## RESPONSES to COMMENTS on the DRAFT IS-MND

This section includes comments received during the circulation of the Draft Initial Study and Mitigated Negative Declaration (IS-MND) prepared for the 12282 Beach Boulevard Mixed-Use Project.

Subject: 12282 Beach Boulevard Mixed-Use Project

Figure 1

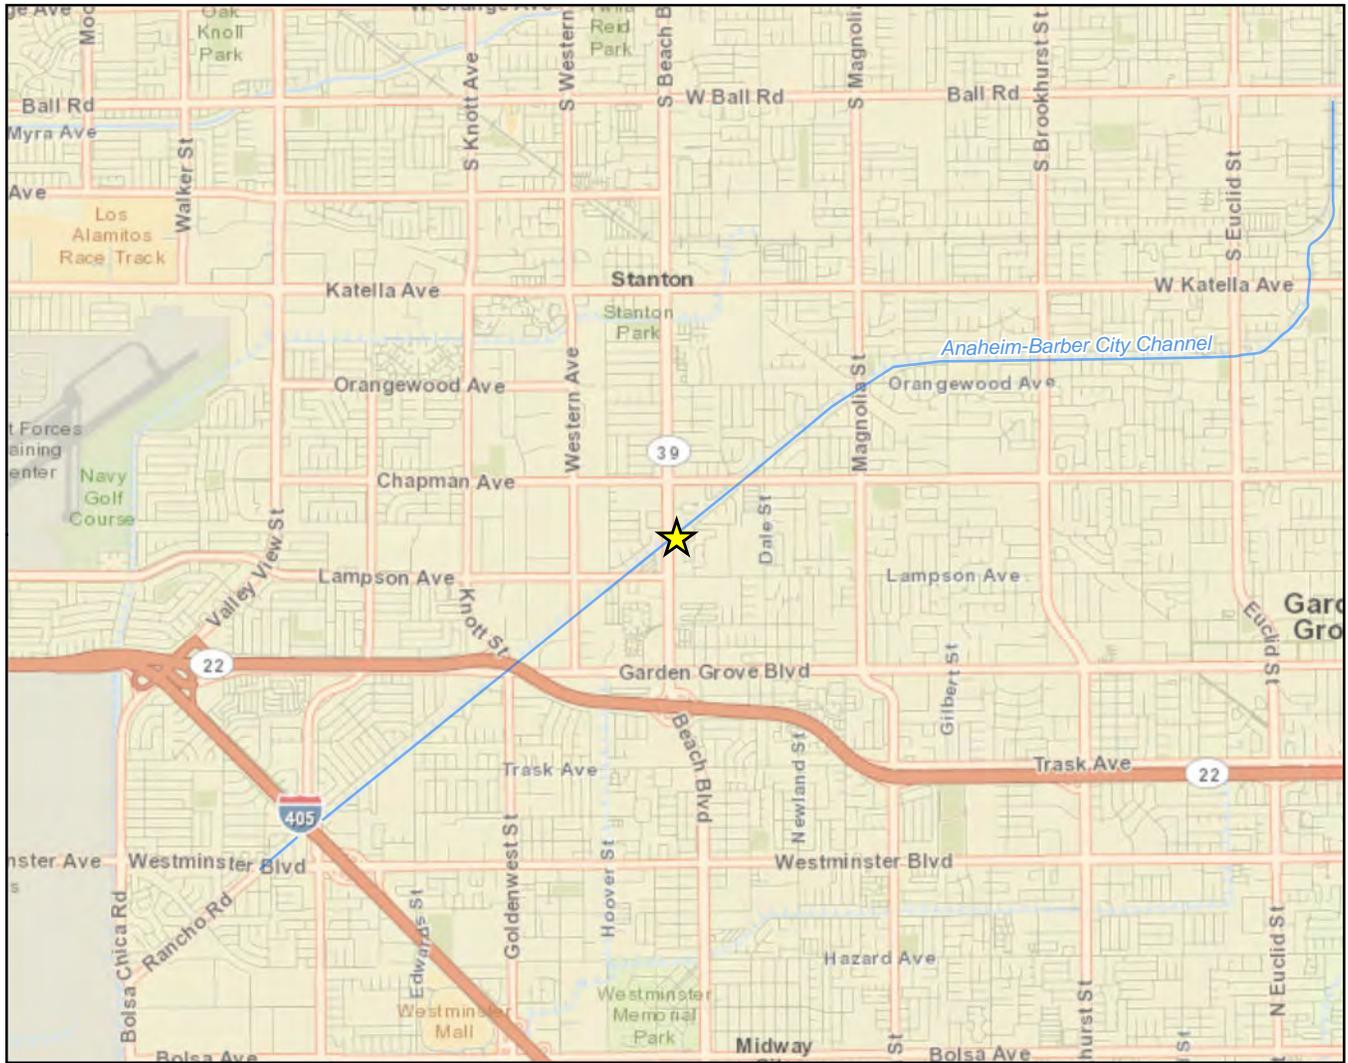
- 2.6 6. Pages 3, 4, and 7 of the Draft IS-MND: The storm channel that abuts the project site to the north is OCFCD's Anaheim-Barber City Channel. Please indicate on the exhibits.

In reference to pages 3, 4, and 7 of the Draft IS-MND, the commenter requests that the storm channel that abuts the project site to the north (Orange County Flood Control District's Anaheim-Barber City Channel) should be indicated on the exhibits.

Figure 1 illustrates the regional location of the project site in proximity to the Pacific Ocean and the Anaheim-Barber City Channel adjacent to the project site. Figure 2 and Figure 4 both show the project site boundary and the proximity to the adjacent Anaheim-Barber City Channel.
